UNITED STATES PATENT AND TRADEMARK OFFICE

APPLICATION NO.	FILING DATE	FIRST NAMED INVENTOR	ATTORNEY DOCKET NO.	CONFIRMATION NO.
10/765,974	01/29/2004	Yasuhiro Nonaka	P24876	2945
7055	7590	07/25/2005	EXAMINER	
GREENBLUM & BERNSTEIN, P.L.C. 1950 ROLAND CLARKE PLACE RESTON, VA 20191			WALSH, RYAND	
			ART UNIT	PAPER NUMBER
			2852

Office Action Summary

DETAILED ACTION

FIGURE 36 (reference from Okabayashi)

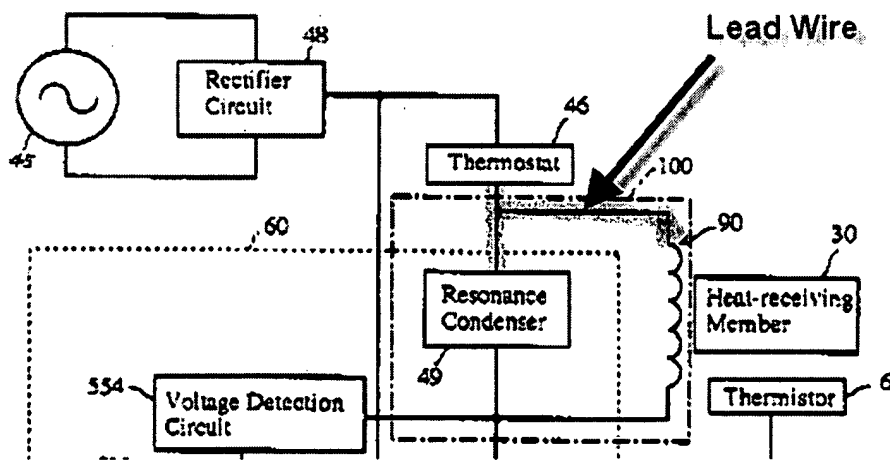
"A heat generating apparatus comprising: a heat generating member (Fig. 36, ref.# 30); an exciting coil (Fig. 36, ref.# 90) provided opposite (Col. 25, Ln. 4-5) to the heat generating member and serving to cause the heat generating member to generate heat by electromagnetic induction; a thermostat (Fig. 36, ref.# 46) provided in the vicinity of the heat generating member and serving to stop supply of a power to the exciting coil when a temperature abnormality of the heat generating member is detected; a power circuit (Fig. 36) having a rectifying circuit (Fig. 36, ref.# 48) and a smoothing circuit (Fig. 36, ref.# 49, note: a resonance circuit [Col. 23, Ln. 7-9] is equivalent to a smoothing circuit) and serving to control the supply of the power to the exciting coil; and a lead wire (see Fig. 36 below) connecting the exciting coil, the thermostat and the power circuit, wherein the thermostat is electrically connected between the rectifying circuit and the smoothing circuit."

"wherein the lead wire (Fig. 36, shown above) shares one of two wires connecting the exciting coil (Fig. 36, ref.# 90) to the inverter power circuit (Fig. 36, ref.# 60) and two wires connecting the thermostat (Fig. 36, ref.# 46) to the inverter power circuit (Fig. 36, ref.# 60)."

"The heat generating apparatus as claimed in claim 5, further comprising, a switching unit voltage detecting circuit (Fig. 36, ref.# 554) which detects that a voltage to be applied to the switching unit exceeds a safe operating voltage range; and a control circuit (Fig. 36, ref.# 525) which controls a power to be supplied to the coil in response to a detection signal of the switching unit voltage detecting circuit."

“wherein when the switching unit voltage detecting circuit (Fig. 36, ref.# 554) detects that the safe operating voltage range of the switching unit is exceeded, the control circuit (Fig. 36, ref.# 525) limits the supply of the power to the exciting coil to carry out a control in such a manner that the voltage to be applied to the switching unit maintains a safe operating voltage range limitation (Col. 26,Ln. 31-41).”

“wherein when the switching unit voltage detecting circuit (Fig. 36, ref.# 554) detects that the safe operating voltage range of the switching unit is exceeded, the control circuit (Fig. 36, ref.# 525) detects the supply of the power to the exciting coil and makes the voltage to be applied to the switching unit attenuate on an optional level within a safe operating voltage range limitation(Col. 26,Ln. 31-41).”

“wherein when the switching unit voltage detecting circuit (Fig. 36, ref.# 554) detects that the safe operating voltage range of the switching unit is exceeded, the control circuit (Fig. 36, ref.# 525) stops the supply of the power to the exciting coil (Col. 26,Ln. 31-41).”
